# Access Compliance Report

## Public Rights-of-Way

### (Curb Ramps)

Intersection ID: 11017	Main Street: DRUMMOND_AV	Cross Street: PARSON_ST	Location: W
ADA ID: 59E8E946C0BD	Ramp Type: Perp	Initial Pass/Fail: Fail	Overall Compliance: No
Severity Score: 13.75			
Codes/Mitigation Info/Possible Solution		Field Measurements/Component Compliance

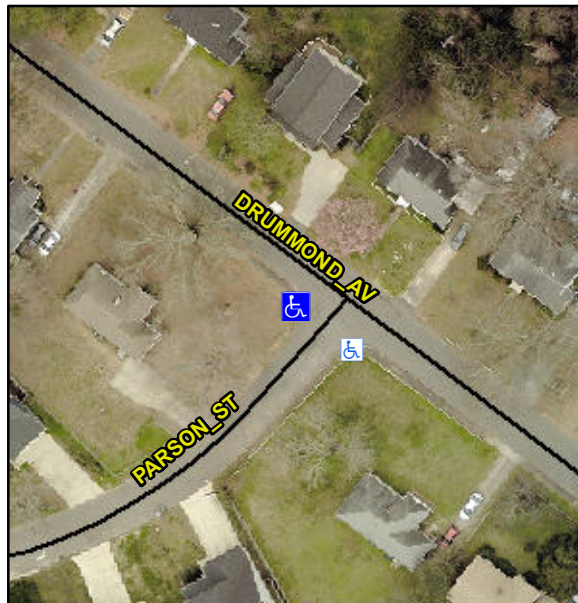
**Not Found, R304.2.2, R304.5.3**

Compliance	Description	Data	Compliance	Description	Data
N/A	Ramp Length (in)	38.5	No	Ramp Slope (%)	11.8
Yes	Ramp Width (in)	48.0	No	Ramp XSlope (%)	4.9
N/A	Flare Type LT	N/A	N/A	Flare Type RT	N/A
N/A	Flare Slope LT (%)	N/A	N/A	Flare Slope RT (%)	N/A
N/A	Flare Traversable LT?	N/A	N/A	Flare Traversable RT?	N/A
N/A	Landing Length (in)	N/A	N/A	DWS Provided?	N/A
N/A	Landing Width (in)	N/A	N/A	DWS Contrast?	N/A
N/A	Landing Slope (%)	N/A	N/A	DWS Length (in)	N/A
N/A	Landing X Slope (%)	N/A	N/A	DWS Full Width?	N/A
N/A	Landing Curb? (Y/N)	N/A	N/A	DWS Offset (in)	N/A
N/A	Shared Landing?	N/A			
N/A	Gutter Ponding?	N/A	N/A	Gutter Slope (%)	N/A
N/A	Gutter Lip Ht (in)	N/A	N/A	Gutter X Slope (%)	N/A
N/A	Painted X Walk1?	No	N/A	Painted X Walk2?	N/A
	X Walk 1 Direction	To SE		X Walk 2 Direction	N/A
N/A	X Walk 1 Width (in)	N/A	N/A	X Walk 2 Width (in)	N/A
	X Walk 1 Slope (%)	4.9		X Walk 2 Slope (%)	N/A
	X Walk 1 X Slope (%)	3.6		X Walk 2 X Slope (%)	N/A

**Remove & Replace Entire Ramp.**
